HISTORIC AND DESIGN REVIEW COMMISSION

HDRC CASE NO: 2020-577
COMMON NAME: 255 Brahan
LEGAL DESCRIPTION: NCB 3856 (255 BRAHAN {AMENDING}), BLOCK 2 LOT 26 & 27
ZONING: RM-4, H
CITY COUNCIL DIST.: 2
DISTRICT: Westfort Historic District
APPLICANT: Cy Goudge/JCG Homes, LLC
OWNER: OCP JCG Westfort, LLC
TYPE OF WORK: Construction of six, 2-story residential structures
APPLICATION RECEIVED: February 16, 2021
60-DAY REVIEW: Not applicable due to City Council Emergency Orders
CASE MANAGER: Edward Hall

Historic and Design Review Commission
Design Review Committee Report

PROJECT TITLE
WEST FORT HOMES
255 BRAHAN BLVD. | SAN ANTONIO, TEXAS | 78215

DRAWING TITLE:
**CONCEPTUAL
SITE PLAN**

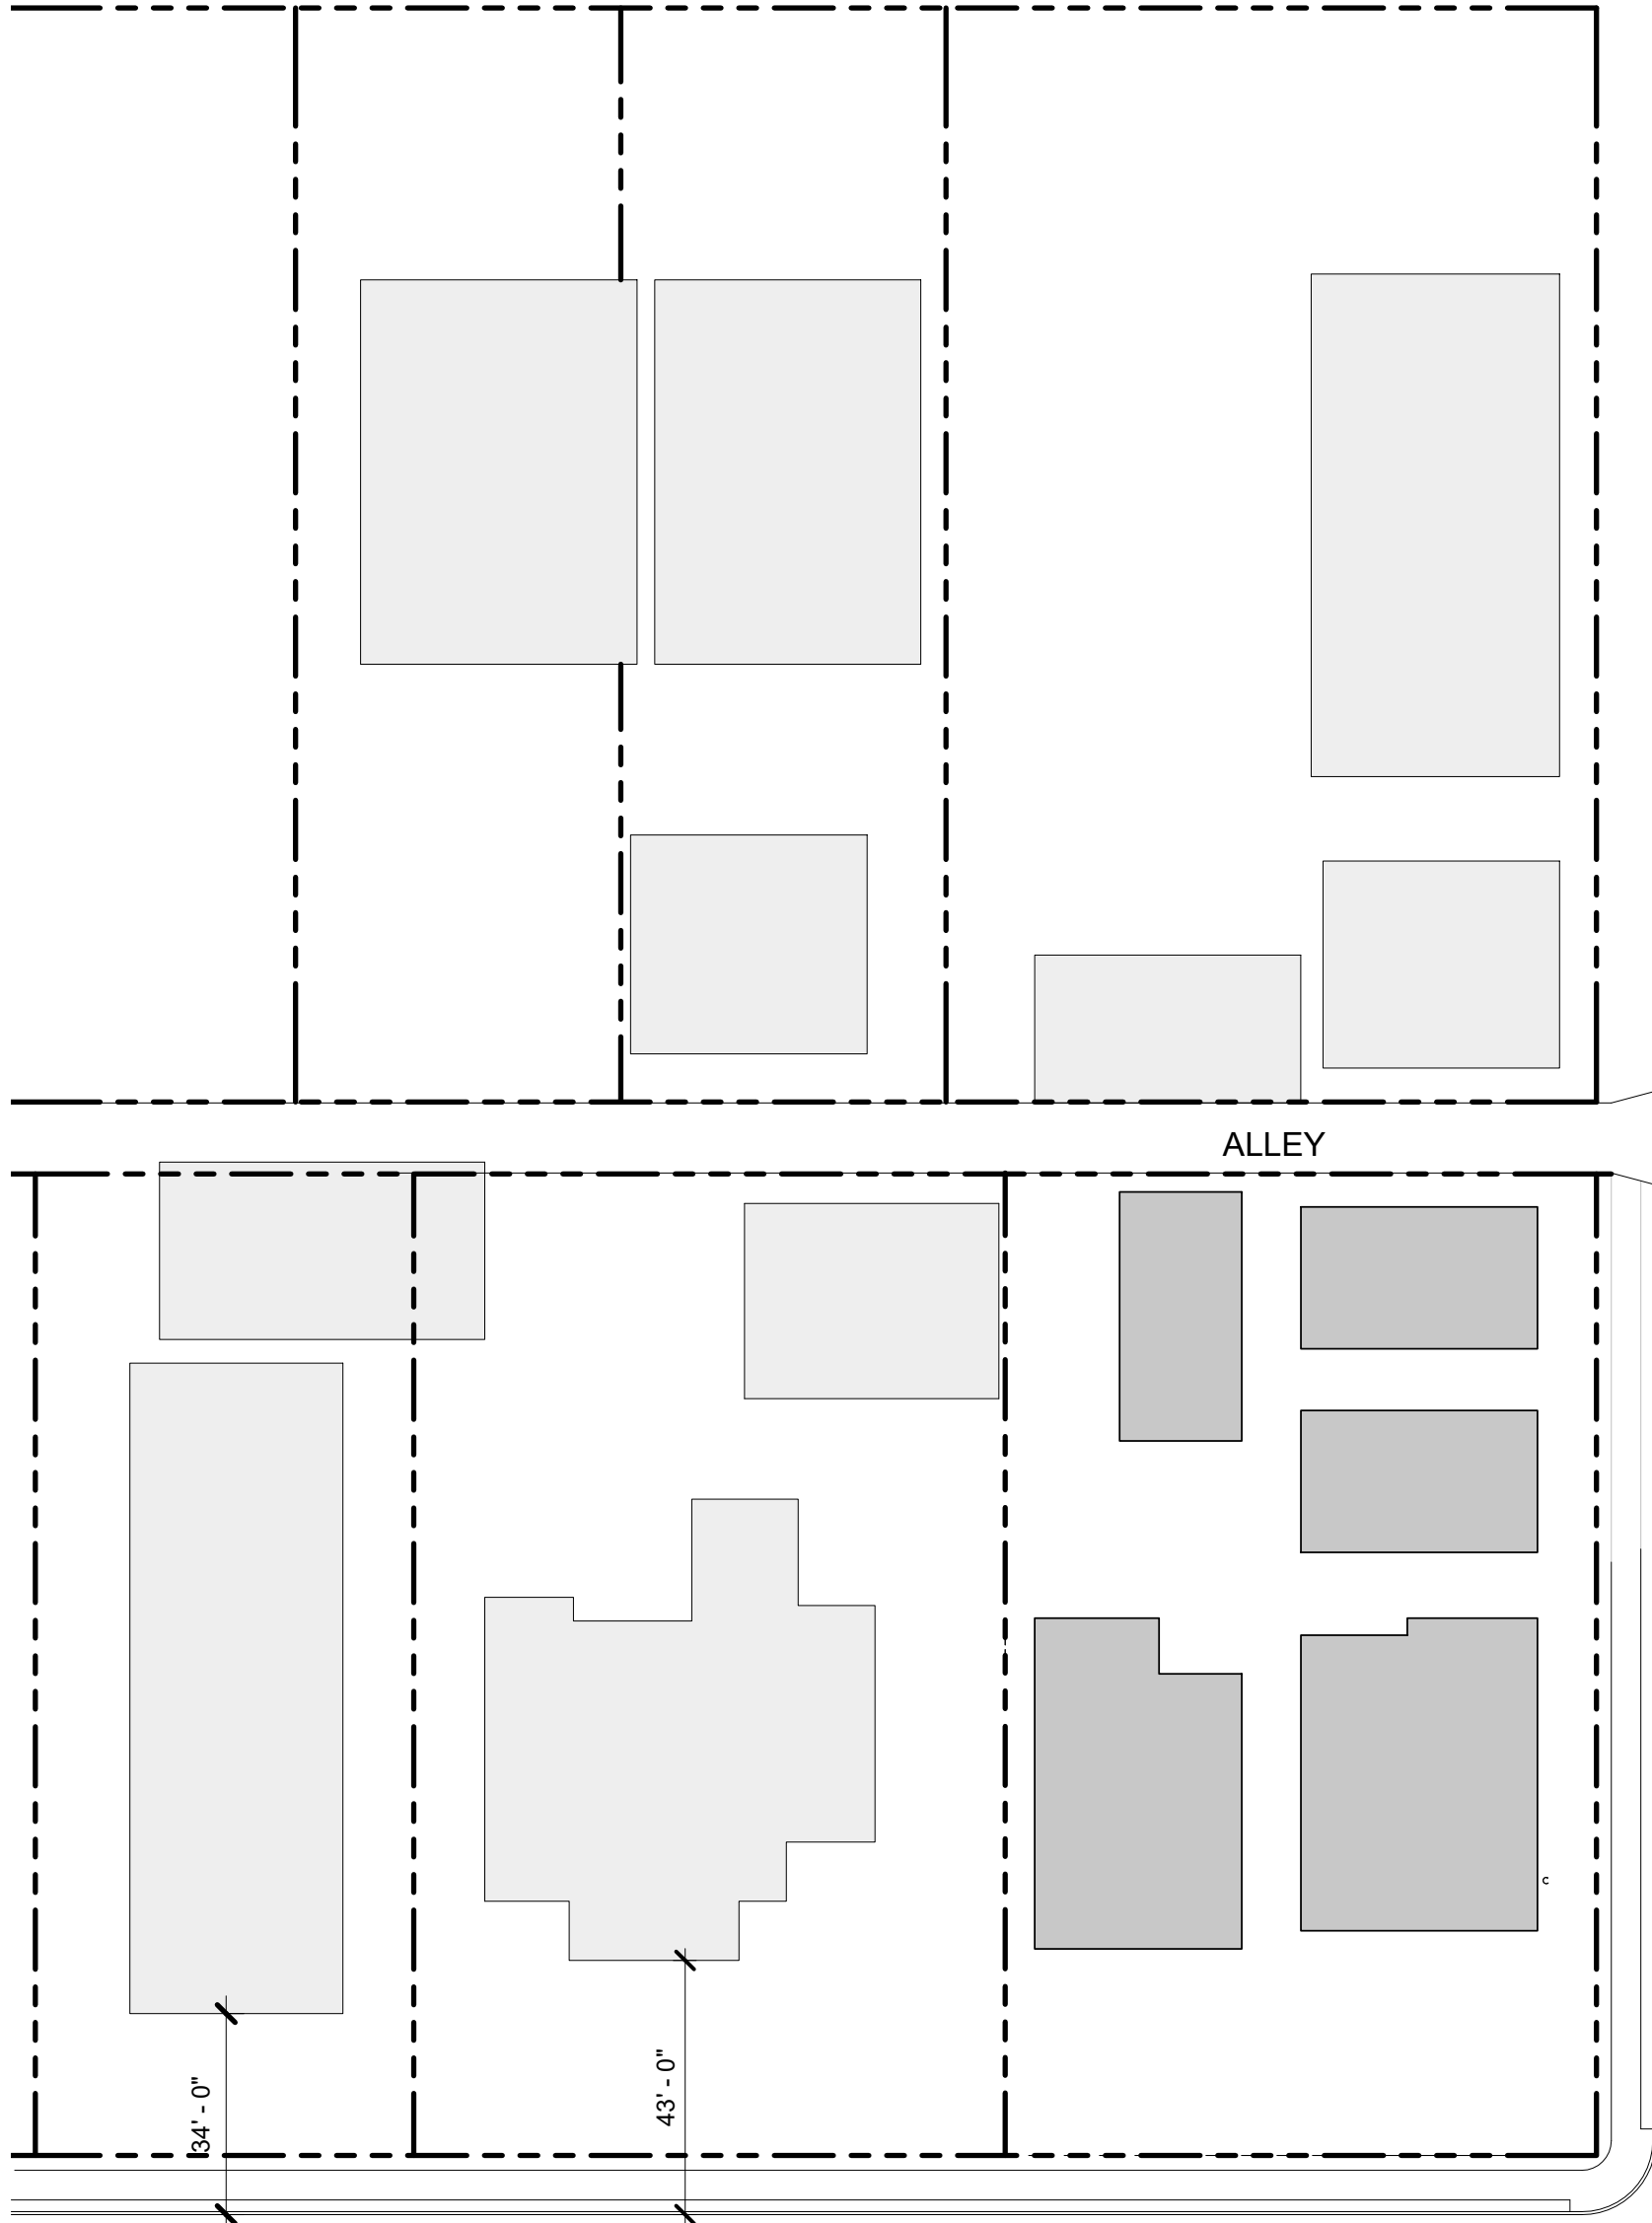
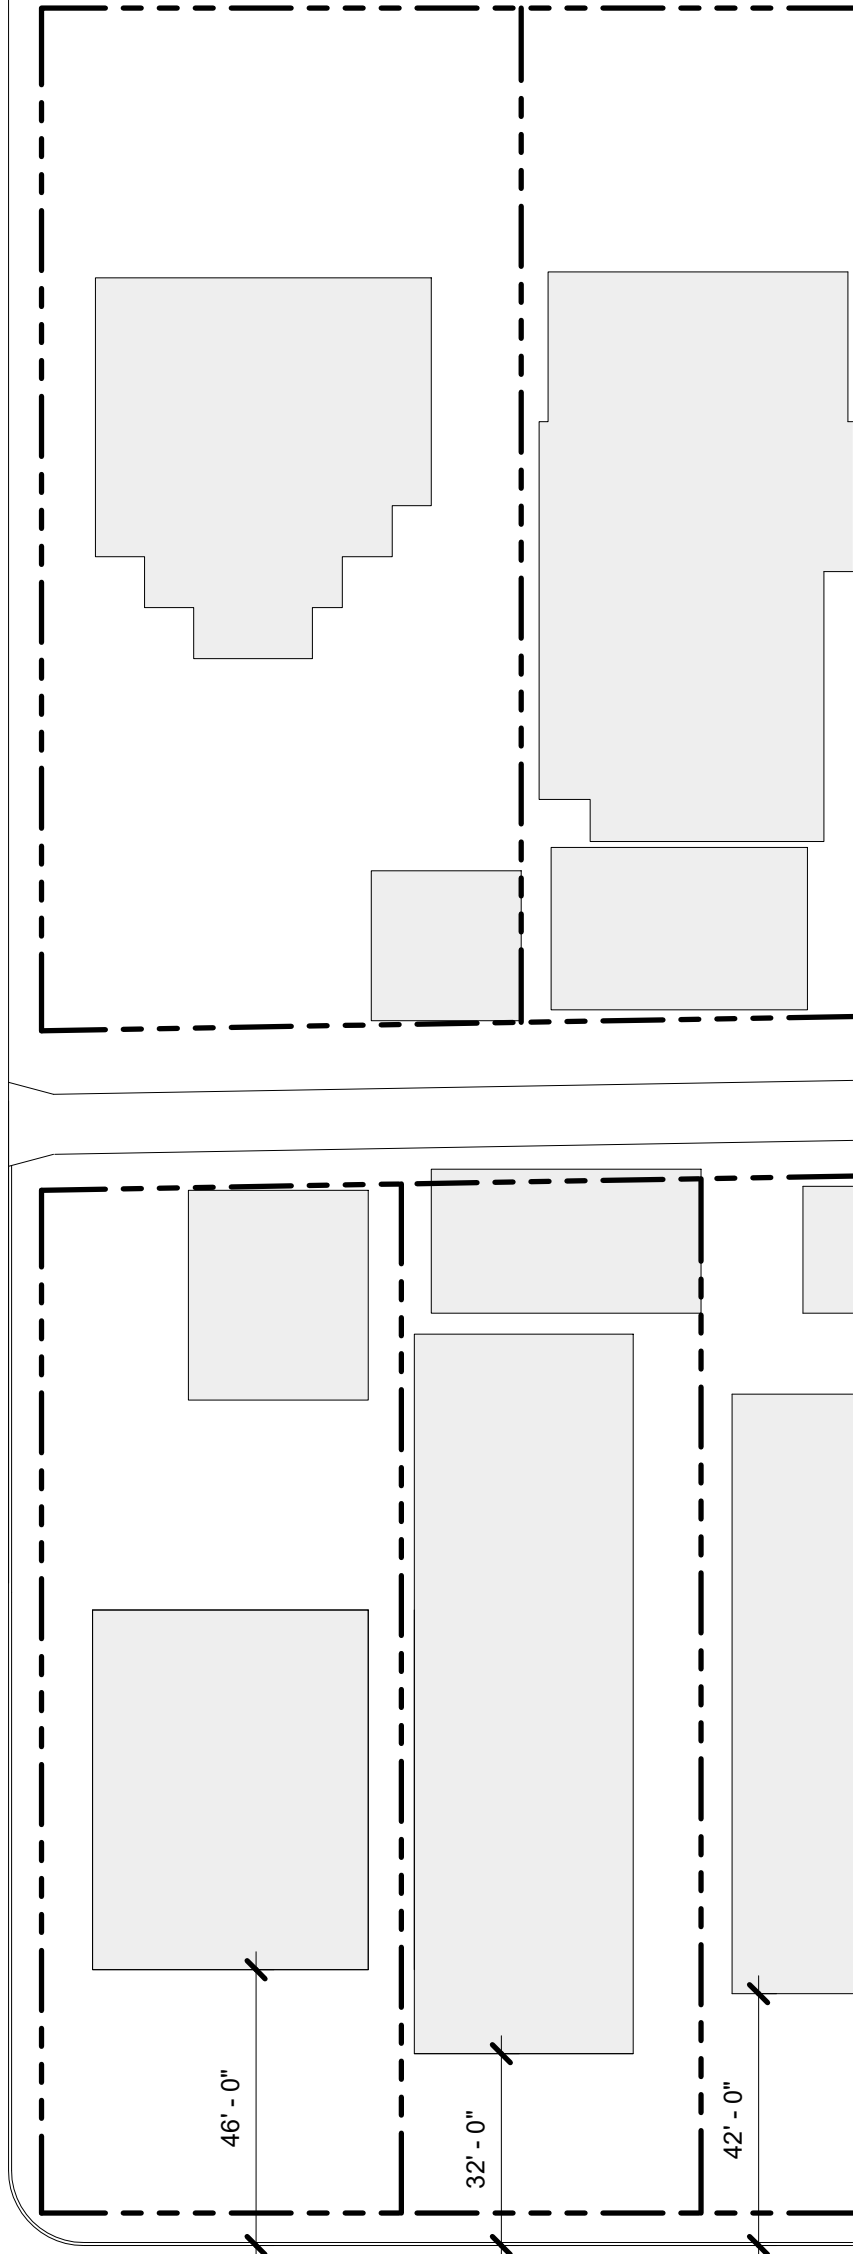
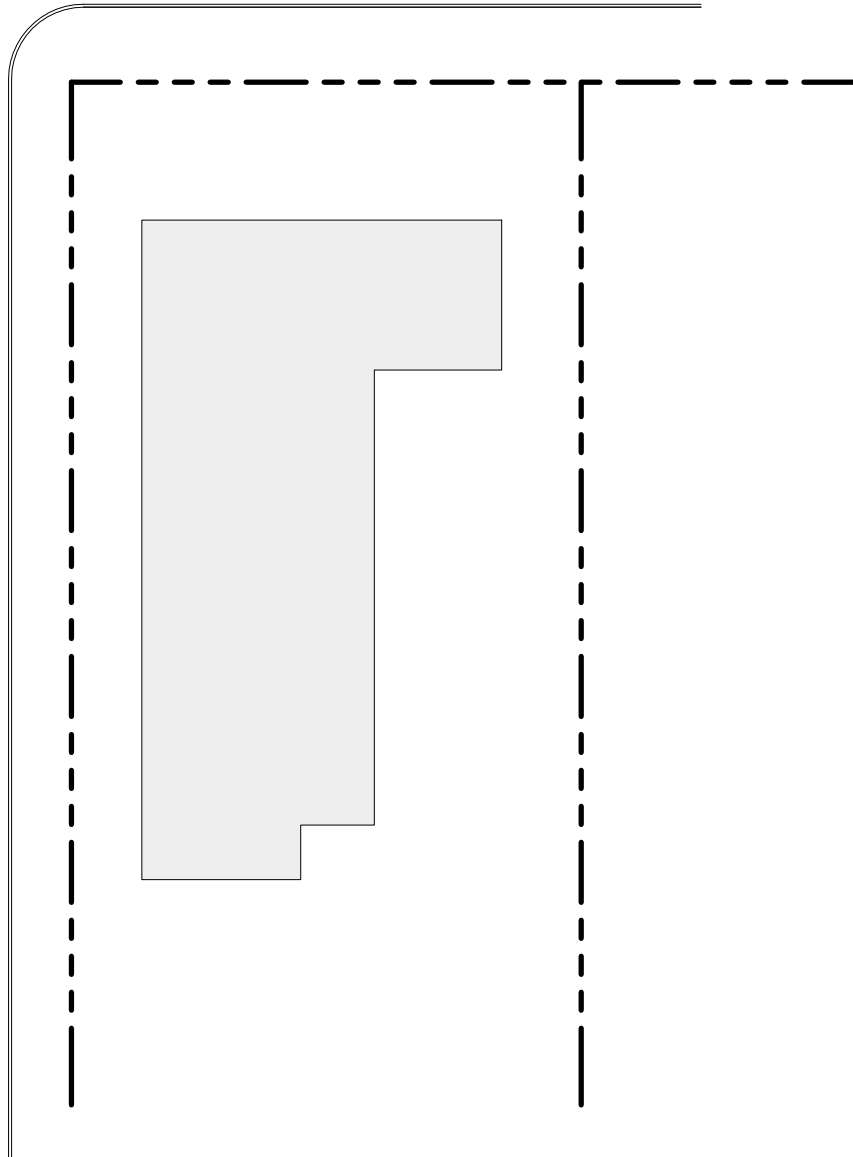
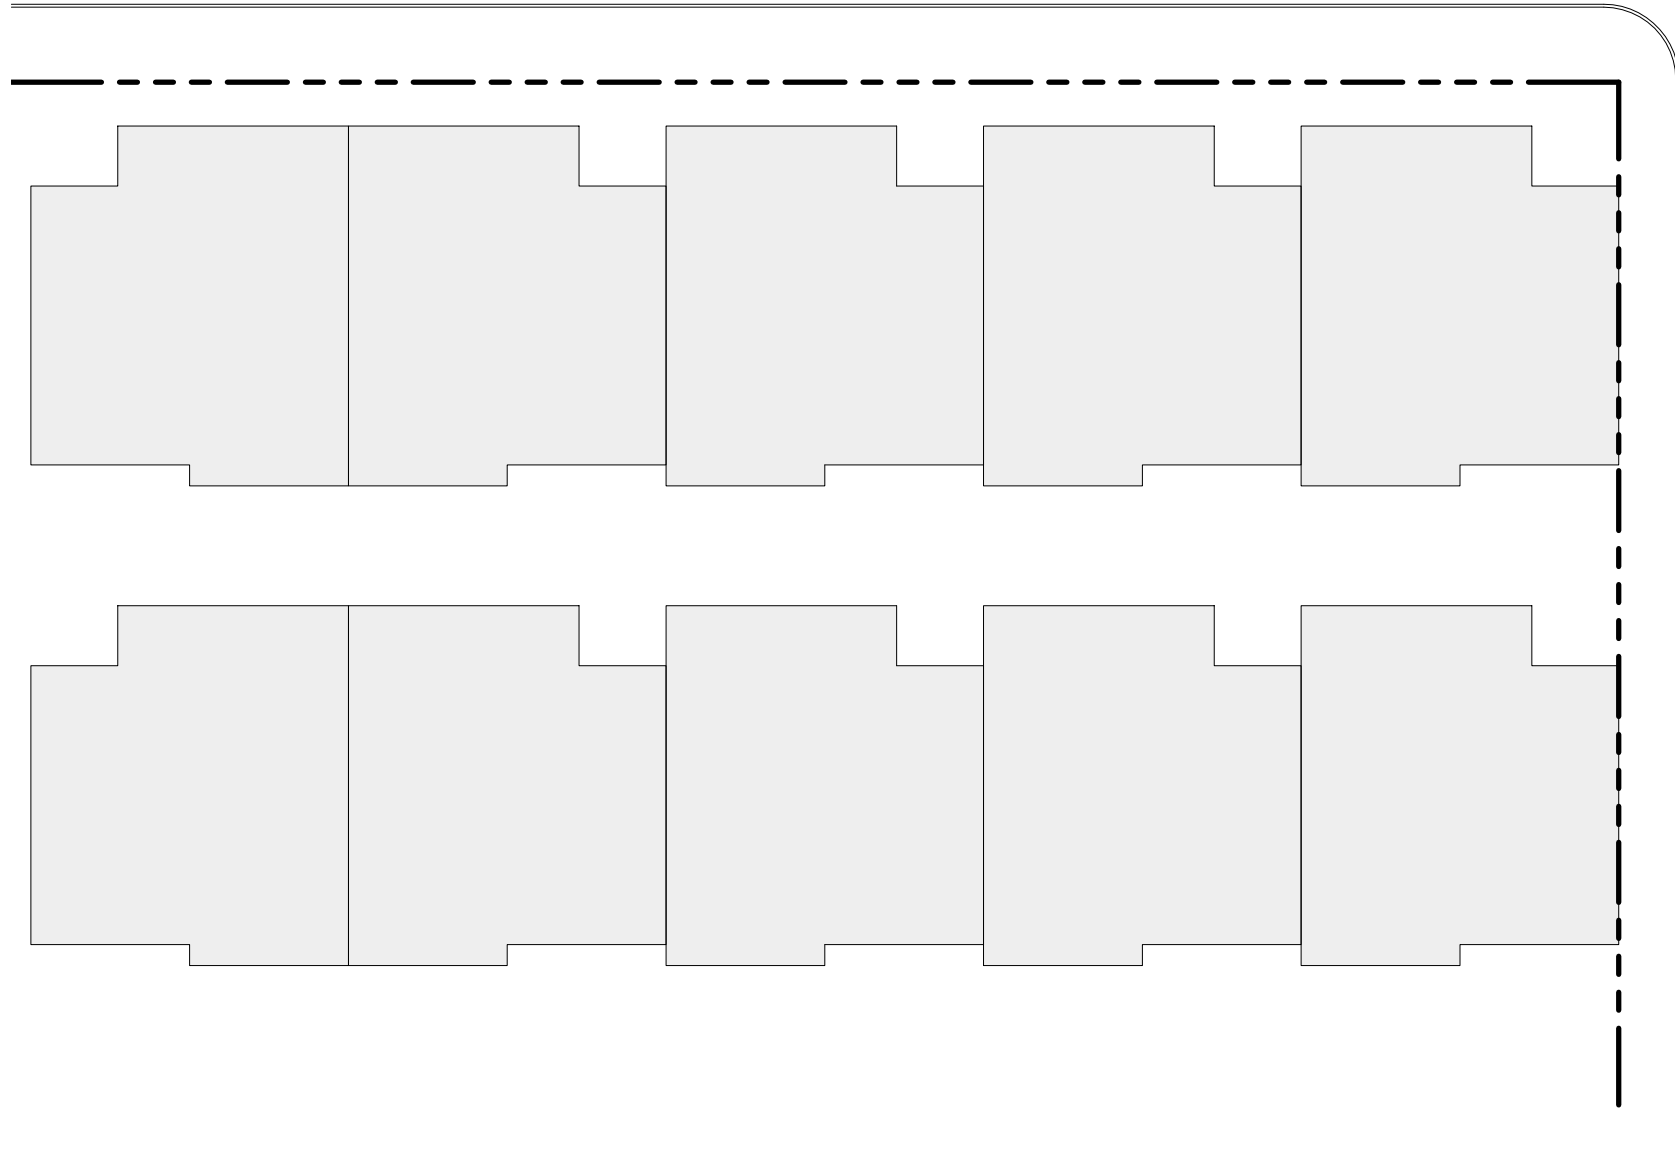
JF: Not too concerned about one large curb cut on Haywood. Recommends that the garage door on Haywood be separated to be consistent with examples found in the neighborhood. Not as much concern about double width garage doors on interior elevations (AMG in agreement). Include windows in top panel of garage doors.

AMG: If an alternative to the ribbon driveway can be found, it would be appropriate (CG – will propose an alternative).

AMG: Outside of driveways, no issue with site configuration.
